# Technical Service Bulletin

## 20 MIL on (DTC P045600 - EVAP System Leak Detected NVLD (very small leak))

20 13 28 2035073/2 November 14, 2013. Supersedes Technical Service Bulletin Group 20 number 13-27 dated October 16, 2013 for reasons listed below.

**Figure 2.** Separate sensor and control module.

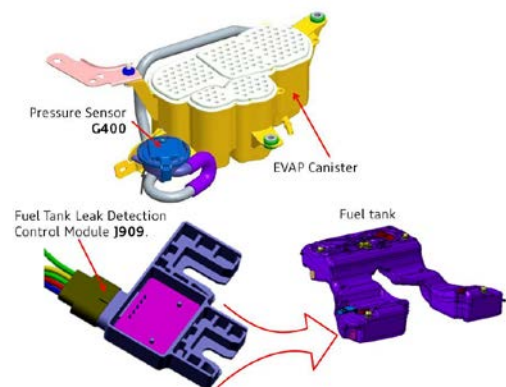
- For vehicles with a fuel tank pressure sensor, G400, and a fuel tank leak detection control module, J909, that are separate (two components): part numbers 8K0906253 and 8K0906253B are superseded to **8K0906253D**.
- For vehicles with a fuel tank pressure sensor, G400, and a fuel tank leak detection control module, J909, which are integrated (one component): part numbers 8K0906253A and 8K0906253C are superseded to **8K0906253E**.

- Separate fuel tank pressure sensor, G400, and fuel tank leak detection control module, J909 (Figure 2).

**Figure 3.** Integrated sensor and control module.

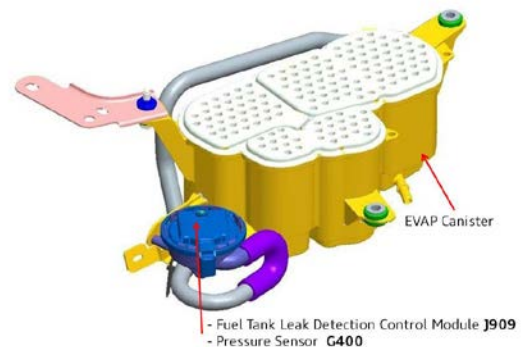
- Integrated fuel tank pressure sensor, G400, and fuel tank leak detection control module, J909 (Figure 3).
